Subject: First Review of Notice of Intention to Commence Large Mining Operations, Geneva Rock Products, Inc., Center Creek Quarry Mine, M/051/0013, Wasatch County, Utah

**FIRST REVIEW OF NOTICE OF INTENTION
TO COMMENCE LARGE MINING OPERATIONS**

**Geneva Rock Products, Inc.
Center Creek**

**M/051/0013
April 05, 2010**

Center Creek Quarry
DOGM NOI
Figure 6

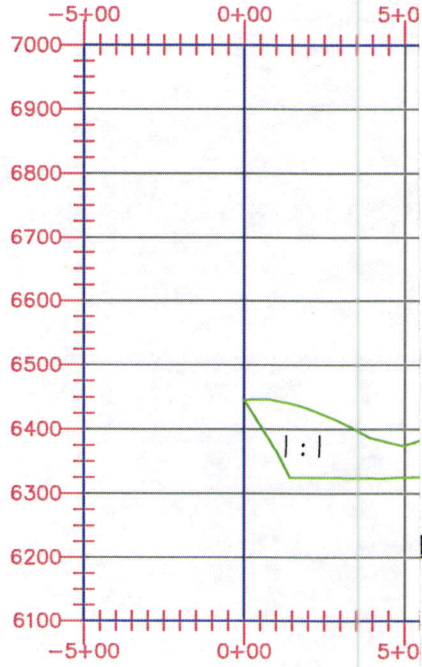
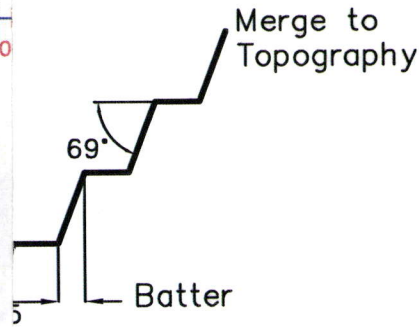
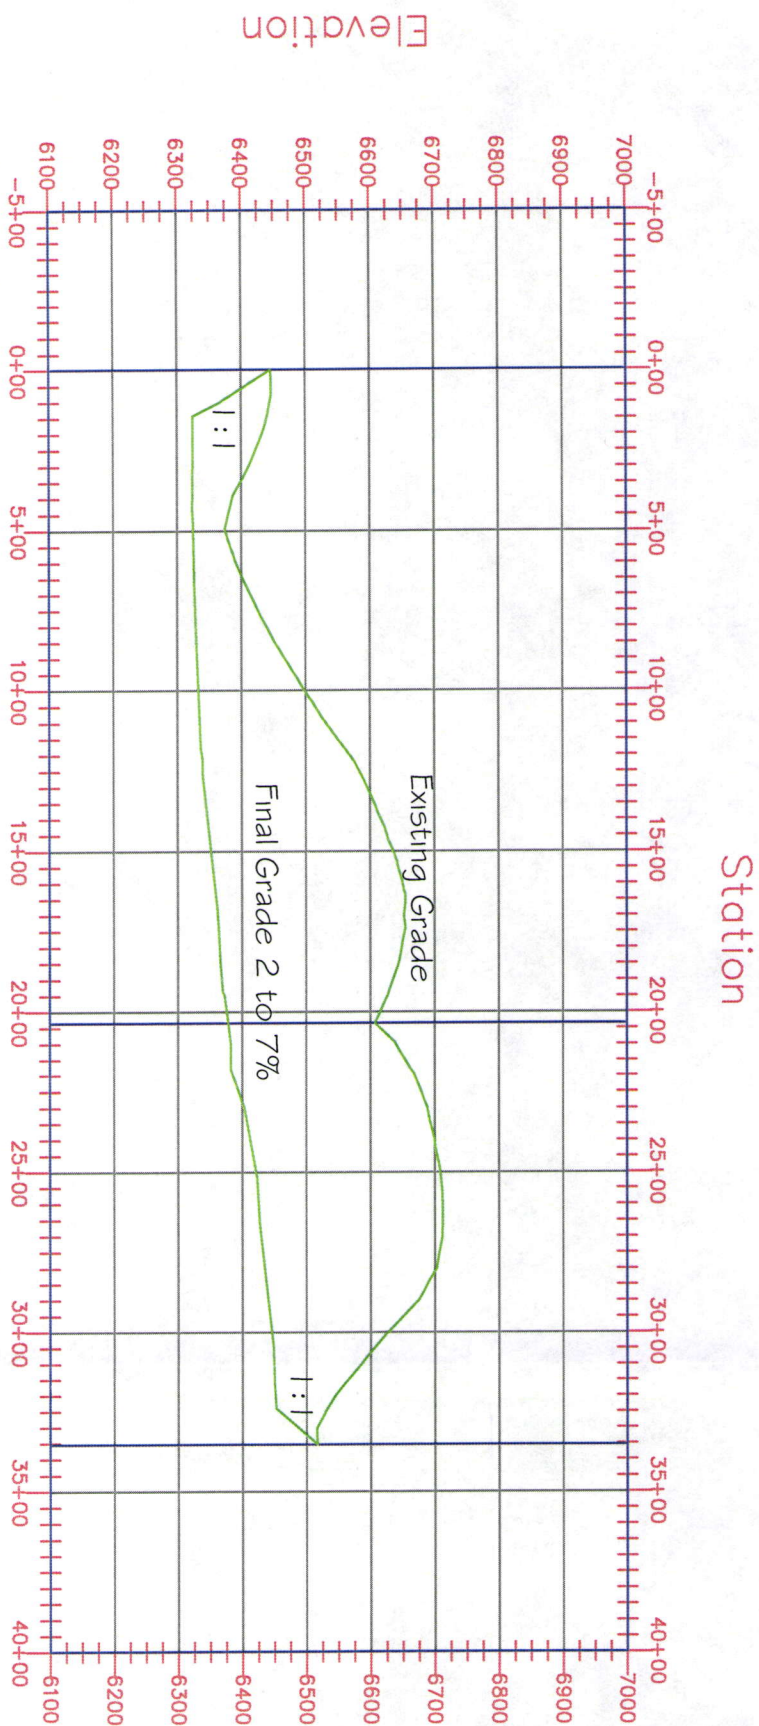
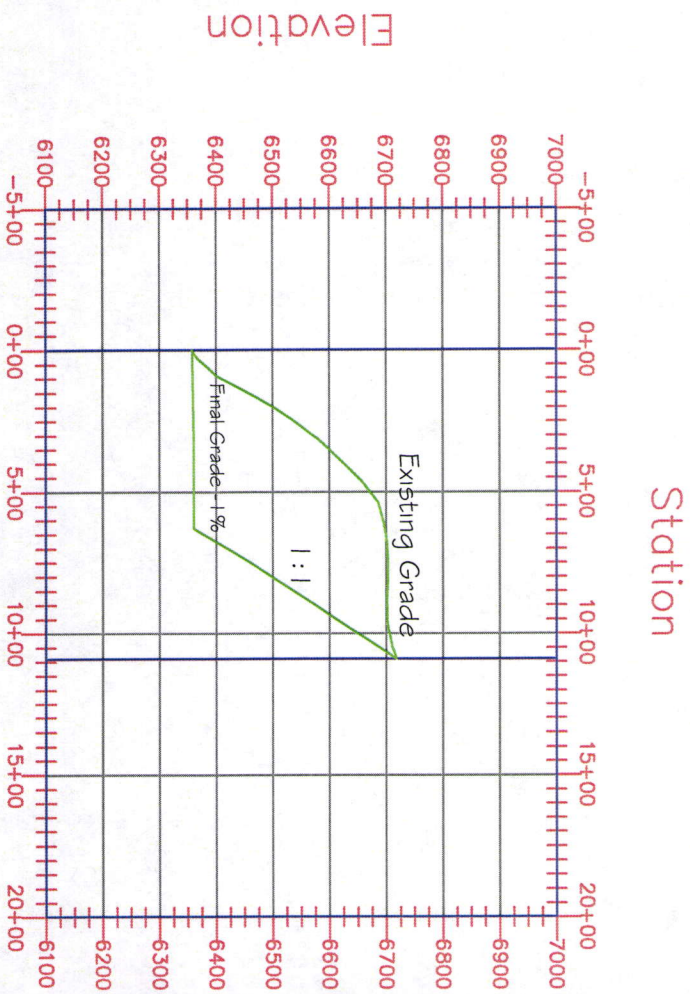
| Comm ent # | Sheet/Page/ Map/Table # | Comments | Initials | Review Action |
|---------------|-------------------------------|---|----------|------------------|
| ✓ 5 | Figure 6 | Label slope angles on the highwalls. | lah | |

| Comm ent # | Sheet/Page/ Map/Table # | Comments | Initials | Review Action |
|---------------|--|---|----------|------------------|
| ✓ 7 | Appendix A Photo O&P ; Figure 6 | The Division would prefer a constant slope angle (with no topsoil and a limited grass/sage brush mix) versus a bench slope angle (with top soiled benches and full vegetation). <i>Optional - we want benches</i> | lah | |
